January 18, 2005

Kewaunee Nuclear Power Plant  
Docket 50-305  
License No. DPR-43

Emergency Plan Revision 27

**ENCLOSURE 1**  
**DESCRIPTION OF CHANGES AND EFFECTIVENESS EVALUATION**

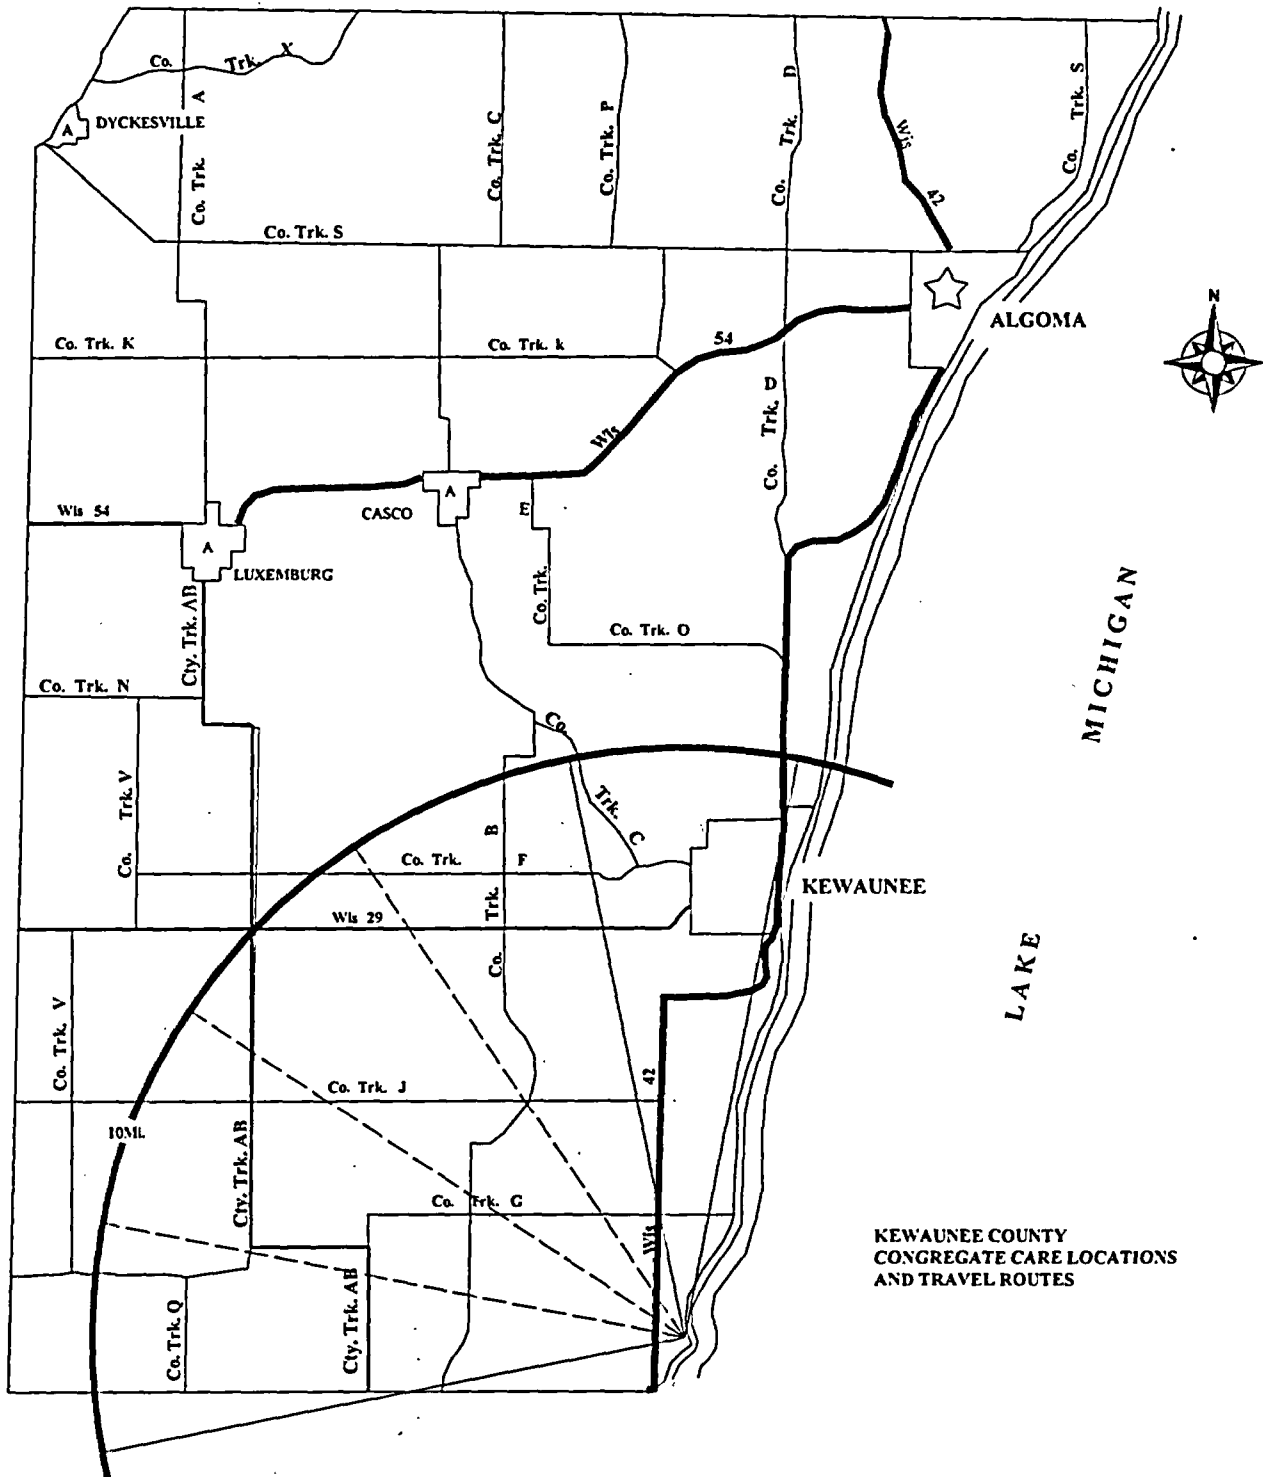
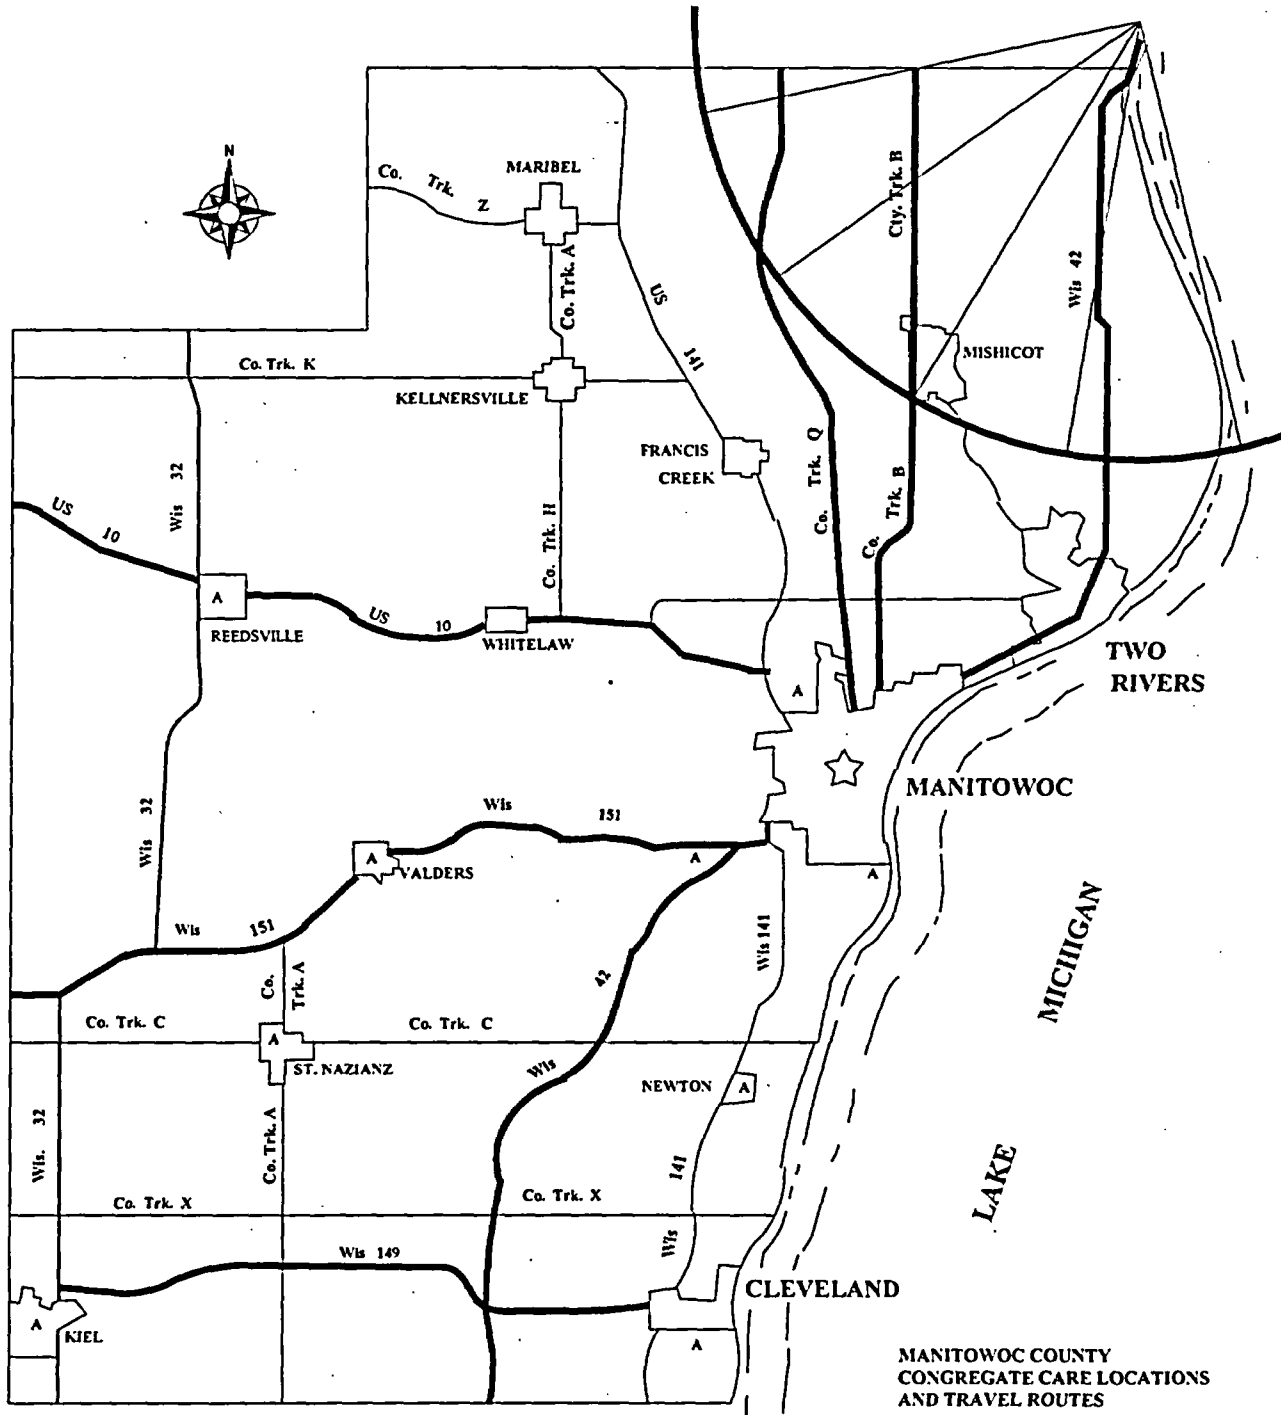
Appendix H			<p>Updated EPZ map and ETE tables.</p>	<p>New data from 2000 census</p>	<p>A new ETE was completed based on 2000 census and any changes in roads which occurred since last ETE study  This change does not reduce effectiveness of the Emergency Plan.</p>
